Informal Document No. GRE-64-49
(64th GRE, 4-7 October 2010,
agenda item 9)

Supplement to the proposal for 04 series of amendments to Regulation No. 10

Submitted by the expert from France

Regulation No. 10

Model A

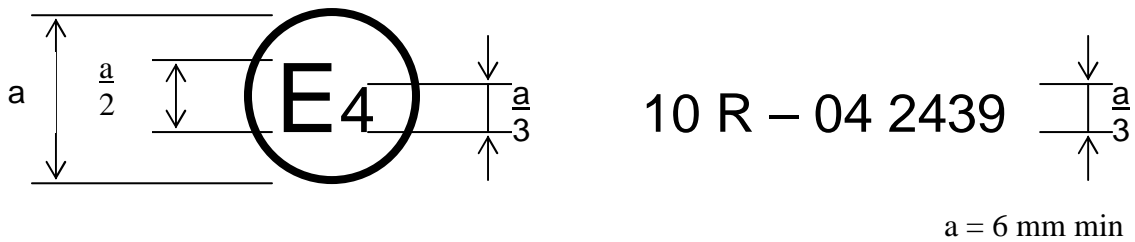
The above approval mark affixed to a vehicle or ESA shows that the vehicle type concerned has, with regard to electromagnetic compatibility, been approved in the Netherlands (E 4) pursuant to Regulation No. 10 under approval **No. 042439**. The approval number indicates that the approval was granted according to the requirements of Regulation No. 10 as amended by the **04** series of amendments.

Figure 3

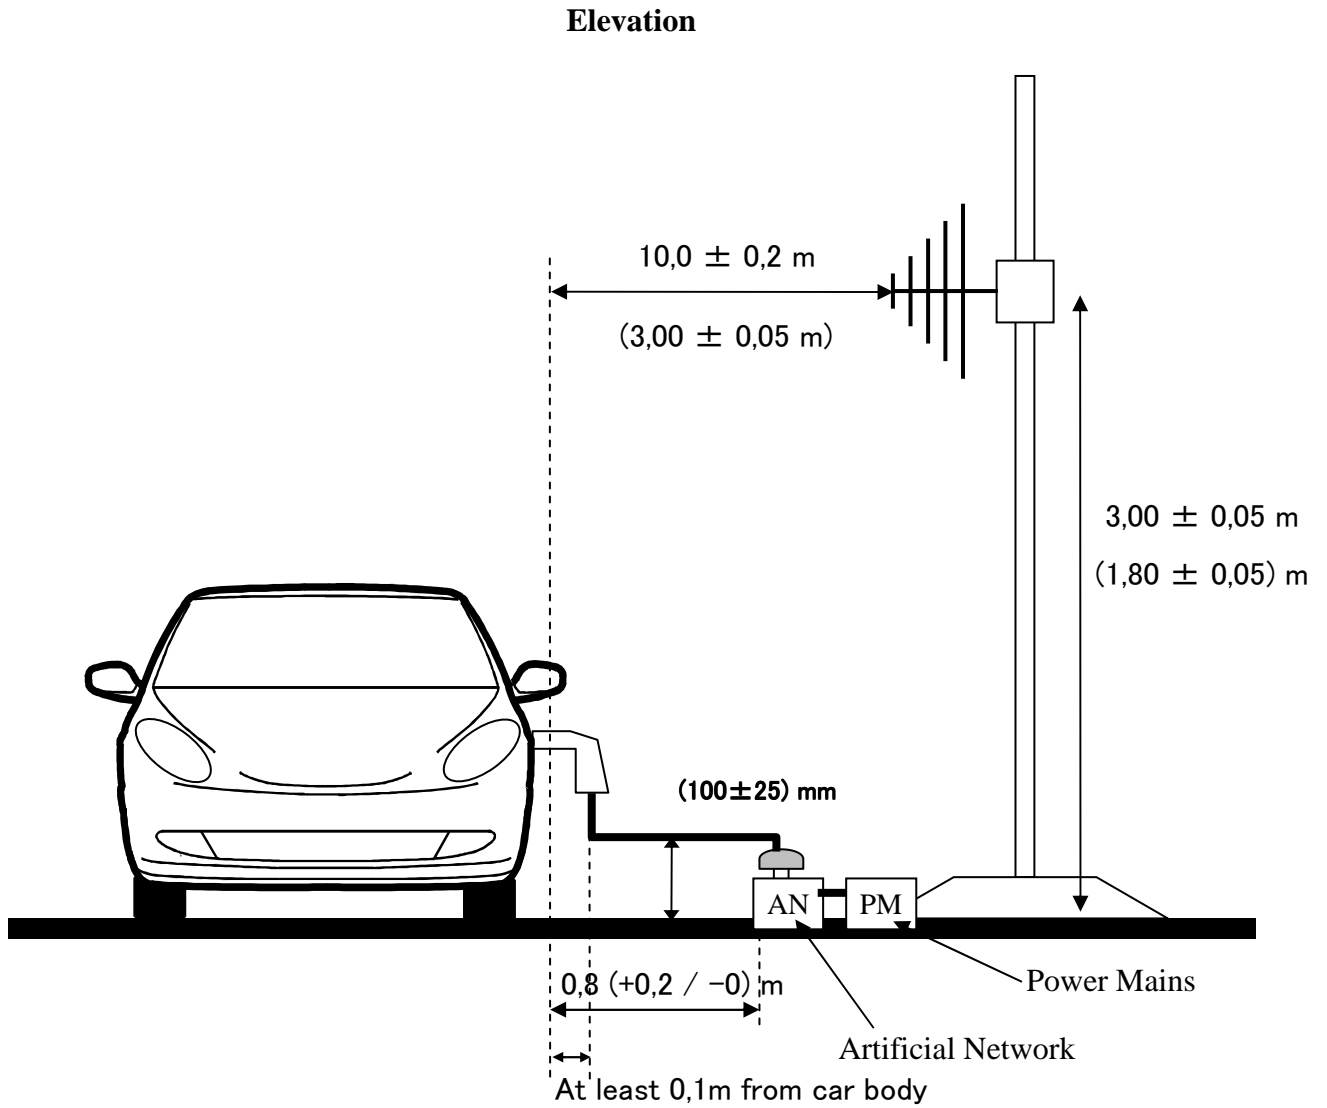
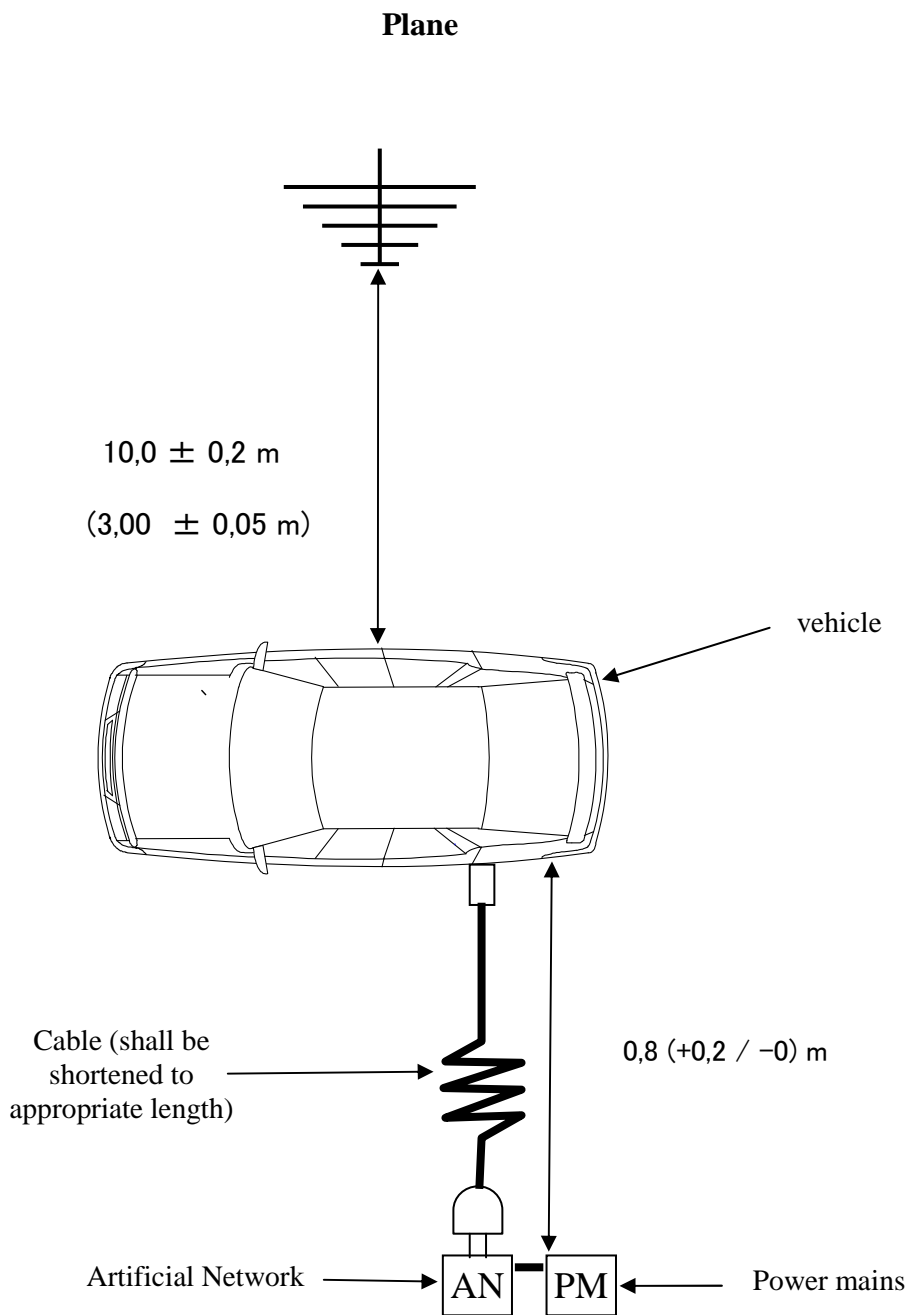
connection of the vehicle in configuration “RESS in charging mode coupled to the power grid” is shown in figure 3 of Appendix 1 to this annex.

Vehicle in configuration “RESS charging mode” coupled to the power grid

Figure 4

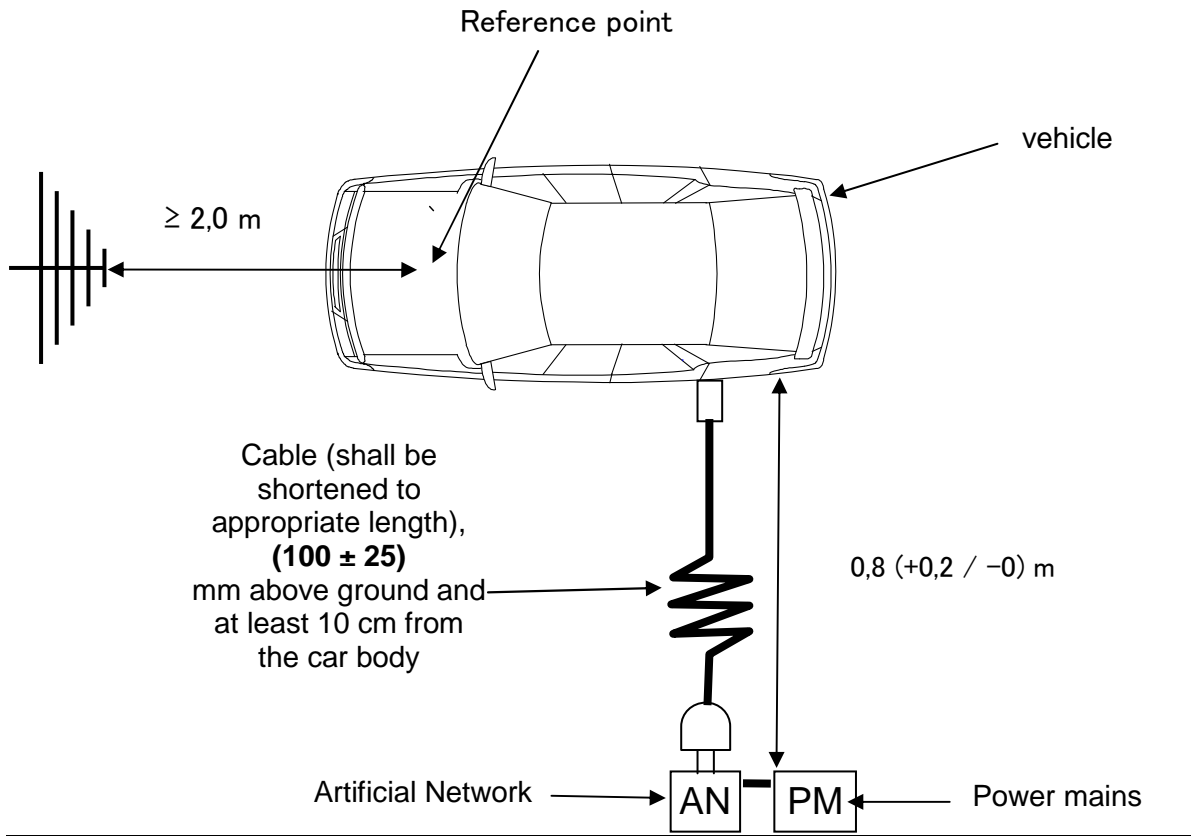
Vehicle in configuration “RESS in charging mode coupled to the power grid”

Figure 1: Vehicle in configuration “RESS charging mode coupled to the power grid” - Single phase charger test set-up

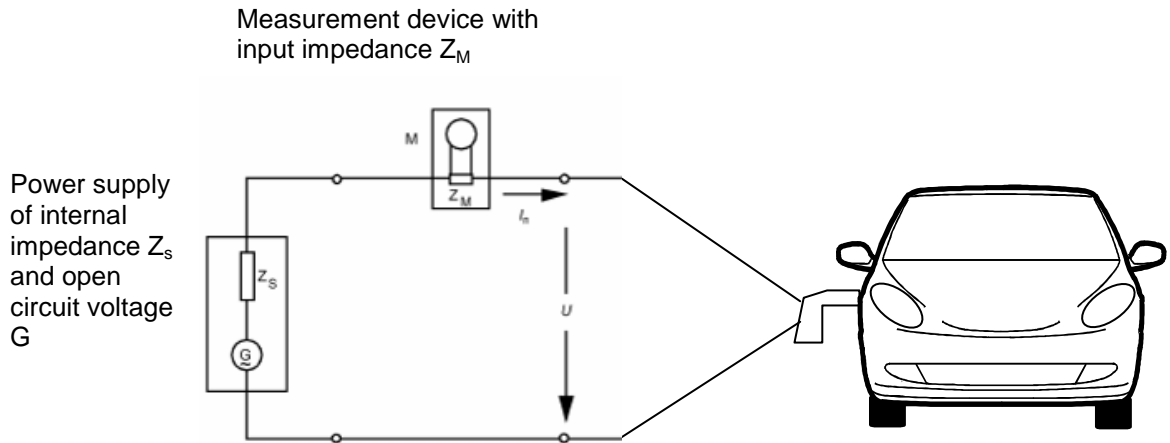
3.2. The test set-up for single phase vehicle in configuration “RESS charging mode coupled to the power grid” is shown in figure 1 of Appendix 1 to this annex.

Figure 2: Vehicle in configuration “RESS charging mode coupled to the power grid” - Three-phase charger test set-up

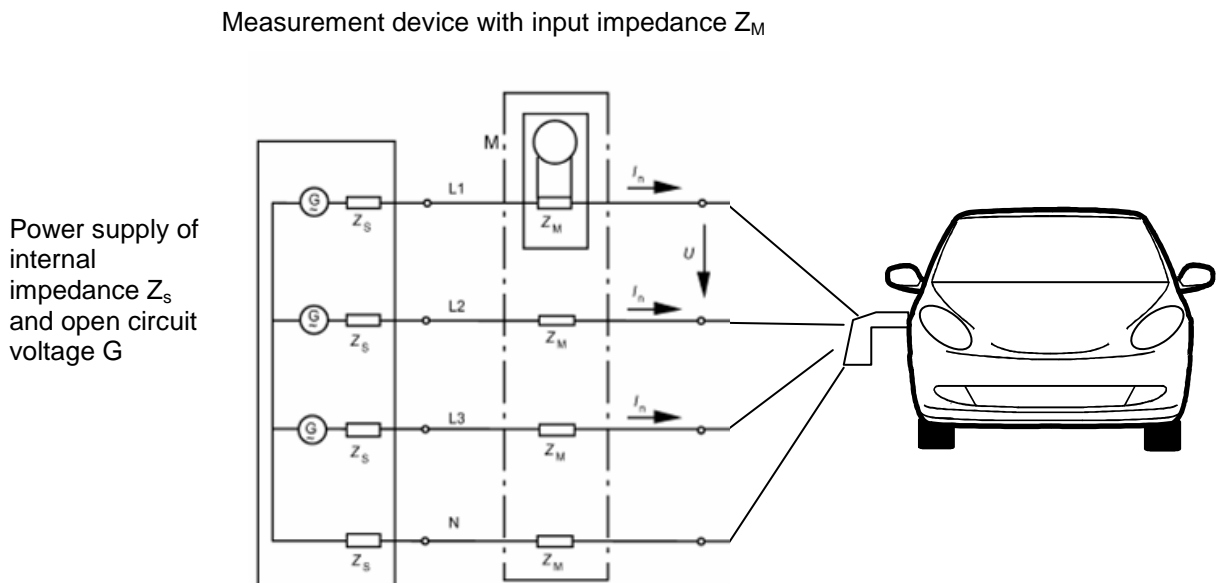
3.3. The test set-up for three-phase vehicle in configuration “RESS charging mode coupled to the power grid” is shown in figure 2 of Appendix 1 to this annex.

Figure 1

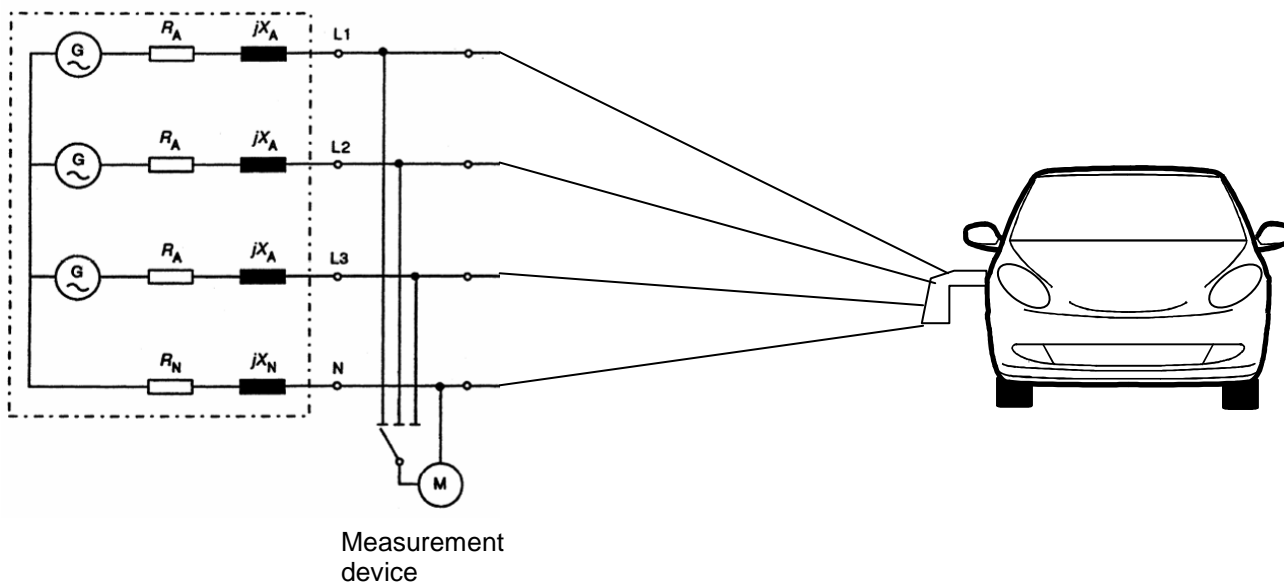
3.3. The test set-up for vehicle in configuration “RESS charging mode coupled to the power grid” is shown in figure 1 of Appendix 1 to this annex.

Vehicle in configuration “RESS charging mode coupled to the power grid”

Figure 1

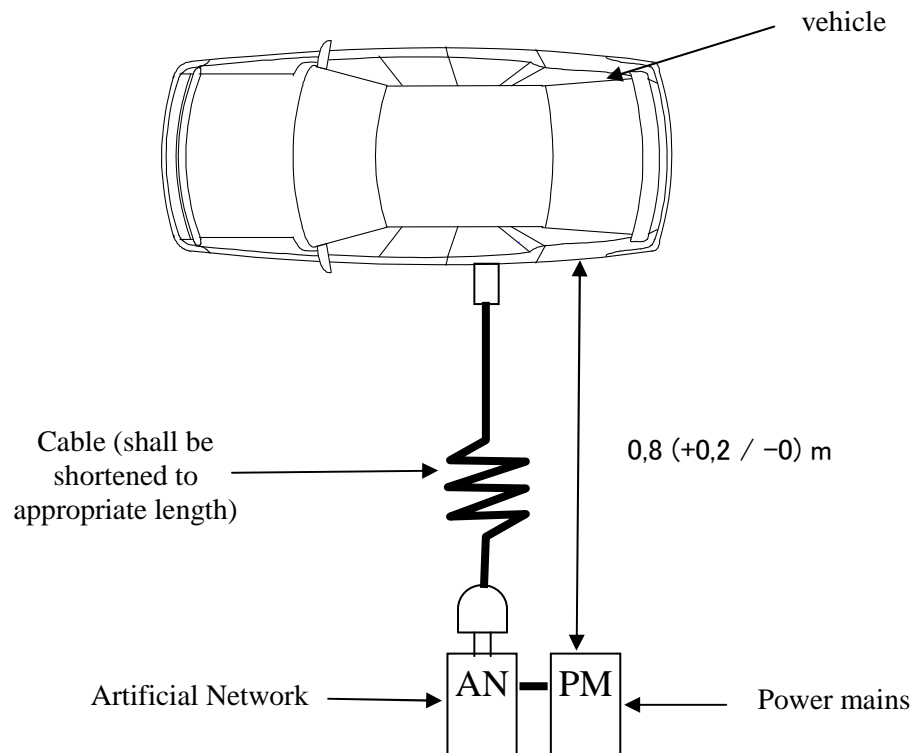
Vehicle in configuration “RESS charging mode coupled to the power grid”

Figure 1

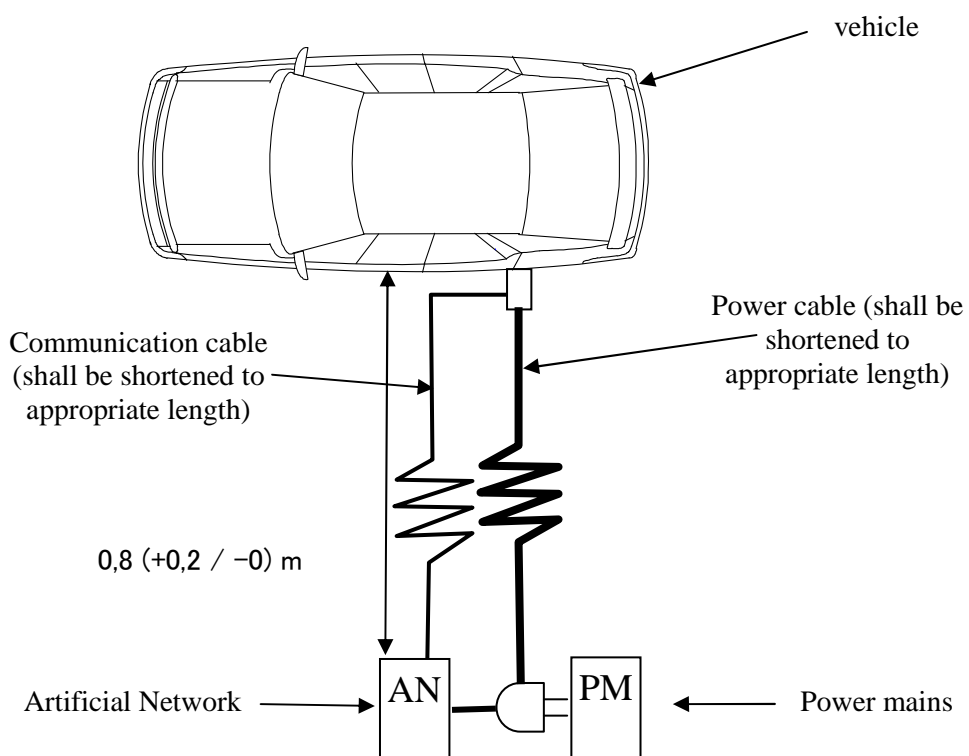
3.3. The test set-up for the connection of the vehicle in configuration “RESS charging mode coupled to the power grid” is shown in figure 1 of Appendix 1 to this annex.

Vehicle in configuration “RESS charging mode coupled to the power grid”

Figure 1

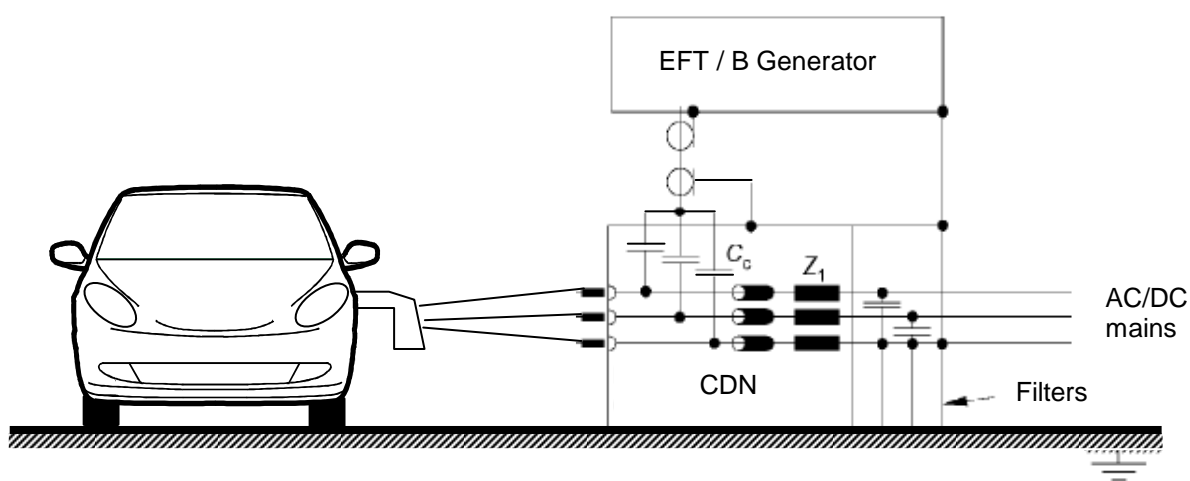
The vehicle shall be positioned on the ground plane. The electrical fast transient / burst (EFT/B) shall be applied on the vehicle on the AC/DC power lines in common modes by using CDN as described in appendix 1, figure 1 of this annex,

**Vehicle in configuration “RESS charging mode” coupled to the power grid
coupling on AC/DC power lines**

Figure 1

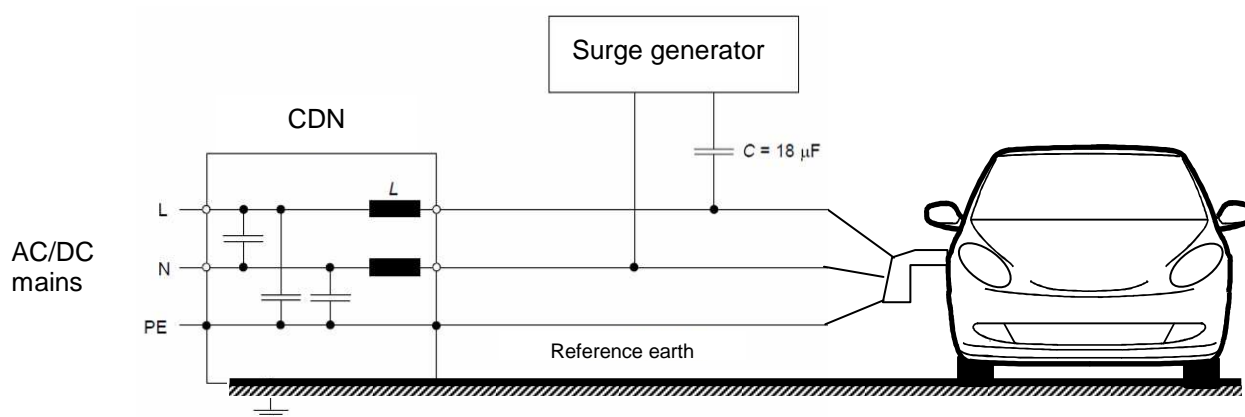
The vehicle shall be positioned on the ground plane. The electrical surge shall be applied on the vehicle on the AC/DC power lines between each line and earth and between lines by using CDN as described in appendix 1, figures 1 to 4 of this annex,

Vehicle in configuration “RESS charging mode coupled to the power grid” - Coupling between lines for DC or AC (single phase) power lines

Figure 2

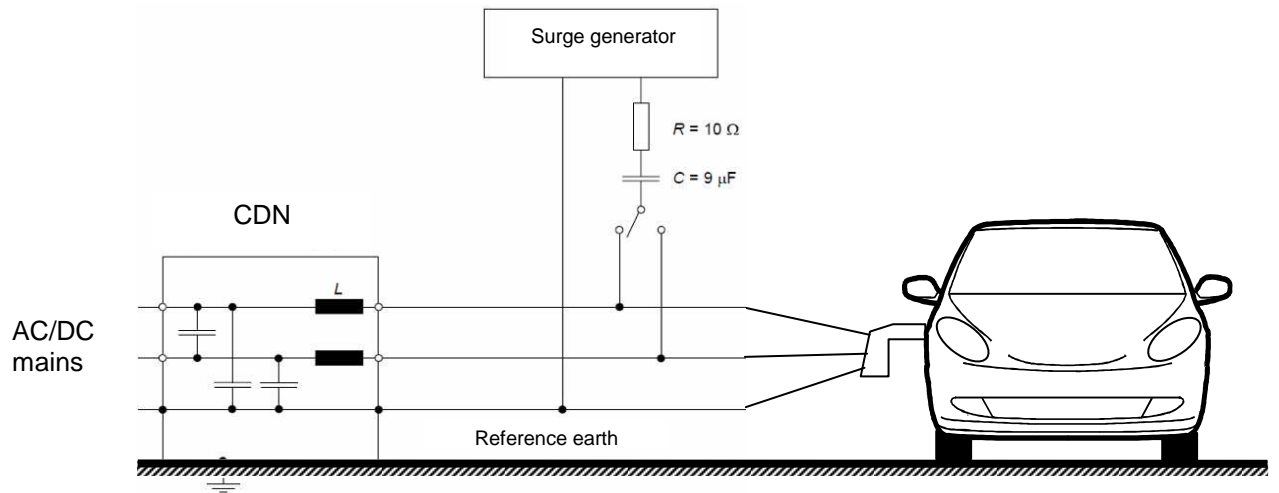
Vehicle in configuration “RESS charging mode coupled to the power grid” - Coupling between each line and earth for DC or AC (single phase) power lines

Figure 3

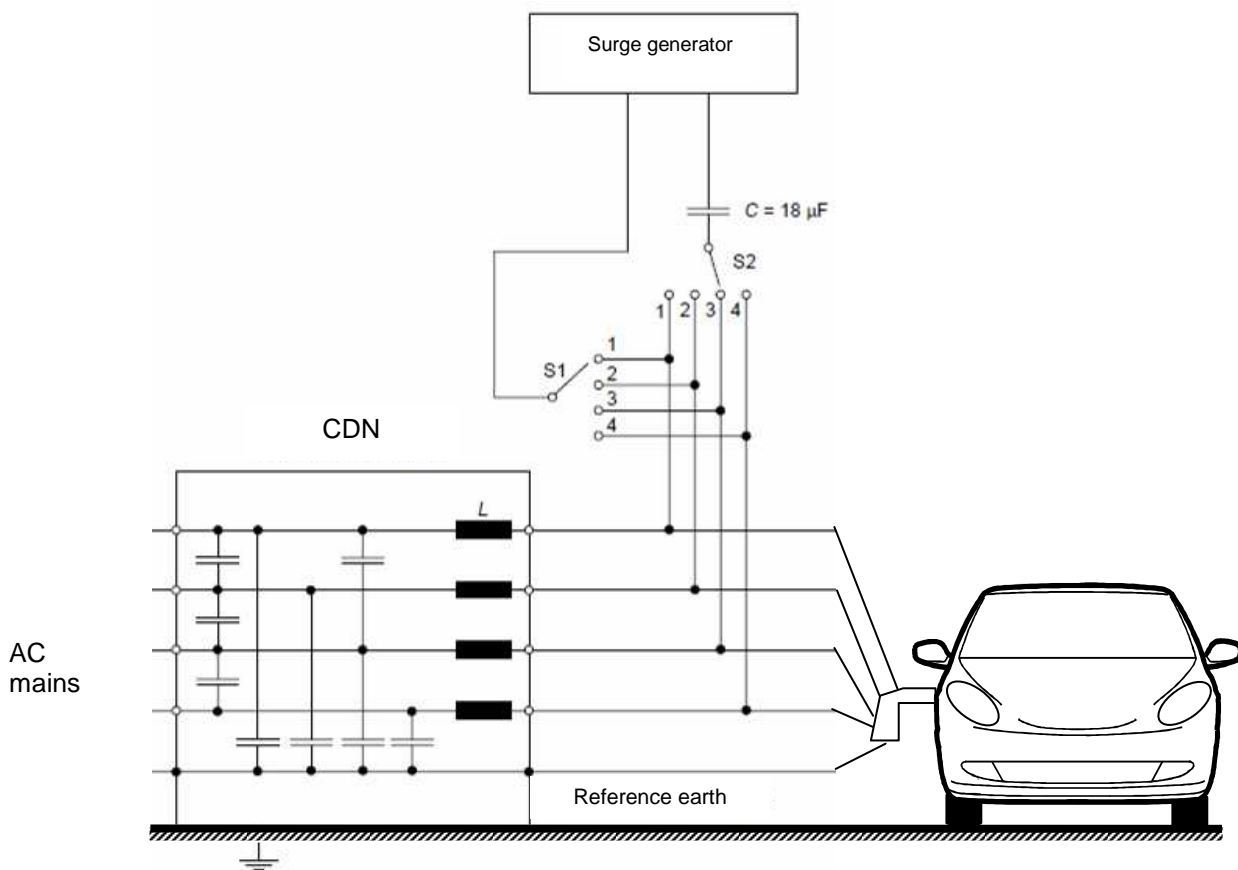
Vehicle in configuration “RESS charging mode coupled to the power grid” - Coupling between lines for AC (three phases) power lines
